UNITED STATES PATENT AND TRADEMARK OFFICE

Office Action Summary	Application No. 10/733,944	Applicant(s) GERFAST, STEN R.	
	Examiner Tran N. Nguyen	Art Unit 2834

DETAILED ACTION

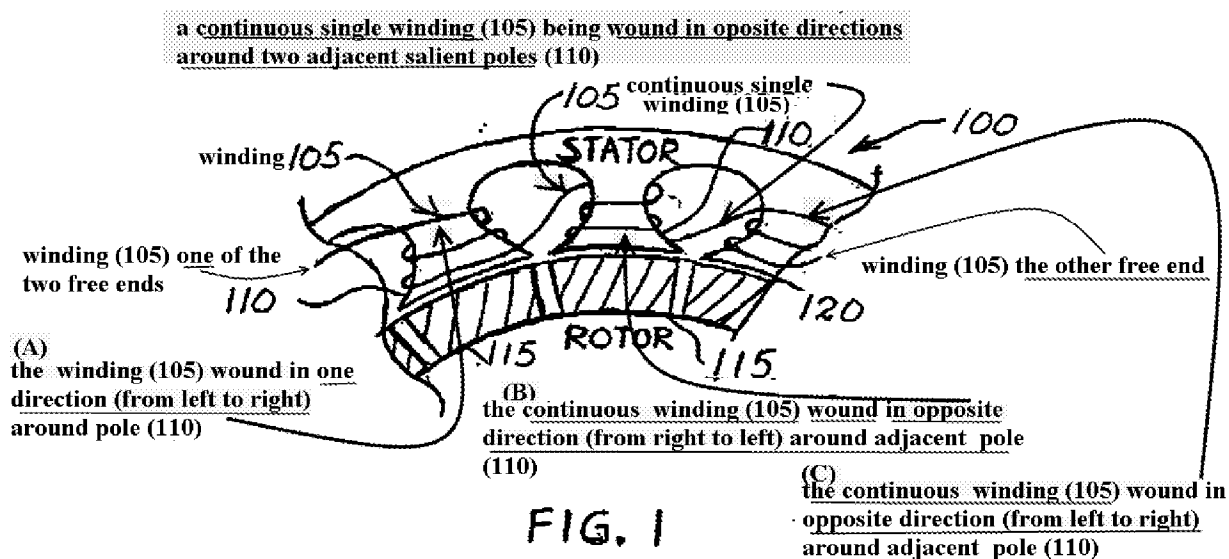
The drawings are objected to under 37 CFR 1.83(a). The drawings must show every feature of the invention specified in the claims. Therefore, the following must be shown:

(1) each salient pole including alternately wound coils coupled to form a single coil, as in claims 1 and 9, must be shown or the features canceled from the claims. *No new matter should be entered.*

As shown in the attached Figure 1, with annotations, a continuous single winding (105) being wound around three salient poles alternately in two opposite directions, as following:

(A) the single winding (105) being wound from *left to right* around a salient pole (110), which is located at the outer-left side in Fig 1, and one free end of the winding (105) is at this outer-left-side salient pole;

(B) the same continuous single winding (105) continuously being wound from *right to left* around adjacent salient pole (110), which is located at the middle in Fig 1; and,

(C) the very same continuous single winding (105) being continuously wound from *left to right* around adjacent salient pole (110), which located at the outer-right side in Fig 1, and the other free end of the continuous single winding (105) is at this outer-right-side salient pole.

Thus, all of Figures 1 of all the drawings, which were filed on 2/24/09, 04/02/06 and 12/12/03, show winding (105) being alternately wound, in opposite directions, around respective **plural** salient poles and the winding (105) being connected in series.

No drawings in the application show **each** salient pole including alternately wound coils coupled to form a single coil, as in claims 1 and 9.

(2) a stator having the same number of salient poles as a rotor having the equal number of rotor poles, as recitation of “a stator with a like number of salient poles” in claims 1 and 9.

Figure 1 only shows partial portion of the stator and the rotor; none of the drawings show a complete figure that illustrates the stator and the rotor having equal numbers of respective stator poles and rotor poles.

(3) the rotor is having claw-shaped magnetic poles, as in claims 5 and 14

Figure 1 only shows partial portion of the stator and the rotor; none of the drawings show the rotor with claw-shaped magnetic poles.

Corrected drawing sheets in compliance with 37 CFR 1.121(d) are required in reply to the Office action to avoid abandonment of the application. Any amended replacement drawing sheet should include all of the figures appearing on the immediate prior version of the sheet, even if only one figure is being amended. The figure or figure number of an amended drawing should not be labeled as “amended.” If a drawing figure is to be canceled, the appropriate figure must be removed from the replacement sheet, and where necessary, the remaining figures must be renumbered and appropriate changes made to the brief description of the several views of the drawings for consistency. Additional replacement sheets may be necessary to show the renumbering of the remaining figures. Each drawing sheet submitted after the filing date of an application must be labeled in the top margin as either “Replacement Sheet” or “New Sheet” pursuant to 37 CFR 1.121(d). If the changes are not accepted by the examiner, the applicant will
